IREDELL COUNTY HEALTH DEPARTMENT
ENVIRONMENTAL HEALTH DIVISION
Application For Improvement Permit
Site Plan Form

MILLS FOREST LOT 4 II

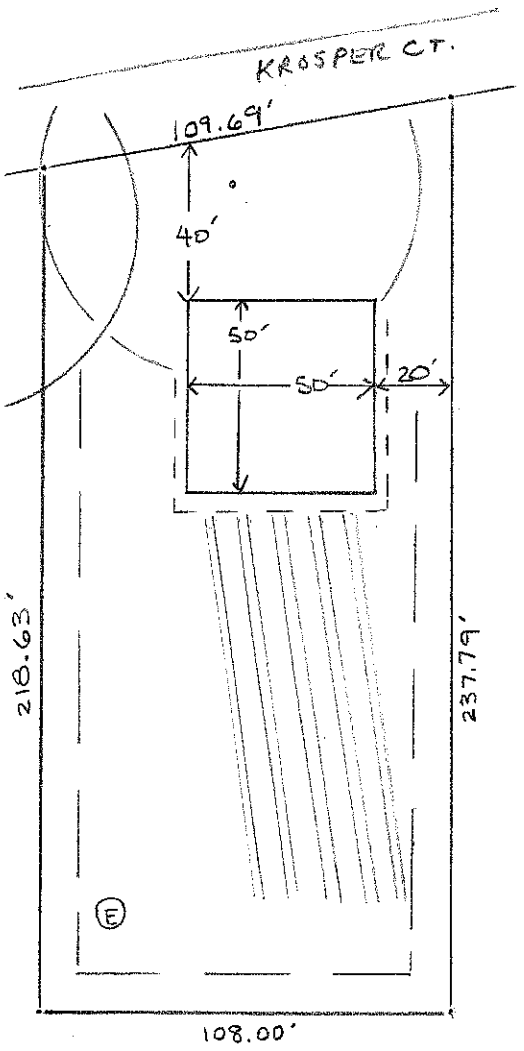
LATERALS SKETCHED DO NOT SHOW EXACT CONTOUR, BUT DO INDICATE THE POSSIBILITY OF A CONVENTIONAL ORIGINAL AND LPP REPAIR.

(E) = ERODED SPOT - NOT USEABLE FOR SEPTIC SYSTEM

THIS LAYOUT REQUIRES THE WELL TO BE PLACED FAIRLY CENTRAL LOT SO THAT THE SETBACK RADIUS DOES NOT ENCROACH BEYOND 10' INTO THE ADJACENT LOTS, AND THEREBY INHIBIT USE OF AN ALTERNATE LAYOUT ON THOSE LOTS.
